PETITION NO: Z-20

ZONING COMMENTS:

The applicant is requesting the R-20 zoning district to develop a single-family detached subdivision. The houses would be traditional and craftsman in styling. The houses would be a minimum 2,000 square-feet, and would start selling for approximately \$275,000. Each house would have an attached two-car garage.

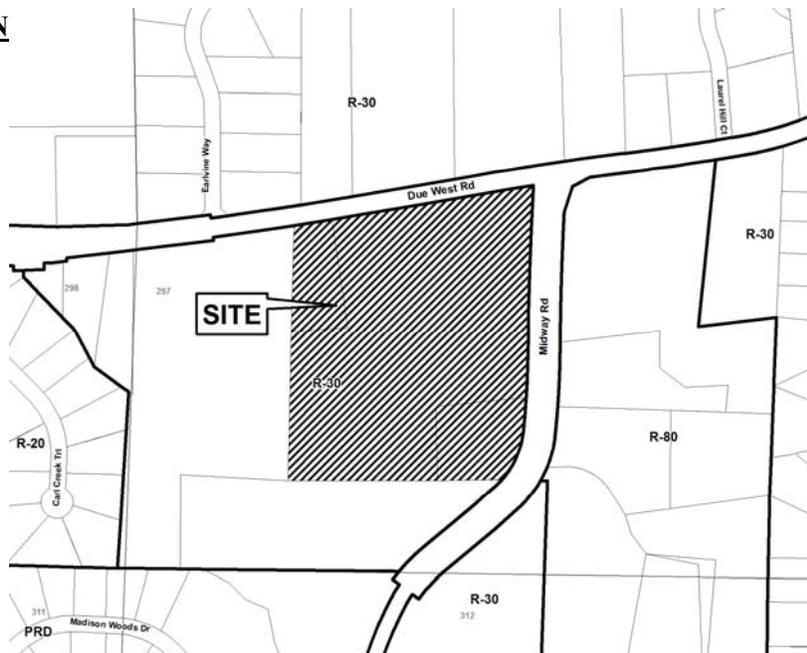
- No Stormwater controls shown _____
- Copy of survey is not current - Additional comments may be forthcoming when current site conditions are exposed.
- No site improvements showing on exhibit.

1. This site is located at the southwest corner of Due West and Midway Roads within the Allatoona Creek Watershed. The majority of the site (12.3 acres) drains to the southwest corner to a well-defined channel that flows to a tributary of Allatoona Creek approximately 300 feet to the west. The remainder of the site (3.4 acres) drains the northwest corner of the site and to the same Allatoona Creek Tributary via the existing roadside ditch along the right-of way of Due West Road. The majority of the site is wooded with several small homestead clearings and open areas near the center and northeast corner of the property. Slopes are moderate and range from 5 to 20 percent with an average of approximately 10 percent.

2. A stormwater management facility is proposed within the natural drainage swale near the southwest corner of the site. The pond appears to be located within the upper end of the stream buffer indicated on the County's Stream Buffer Map. This will need to be field verified prior to LDP approval. If there is a state buffer, then the pond will need to be relocated, possibly resulting in the loss of lot 20. If possible, a concrete wall should be used to limit the dam footprint and the natural storage area utilized to keep clearing and grading to a minimum. The wall appearance could be enhanced with form liners to simulate a masonry wall or painted to blend with the natural area.
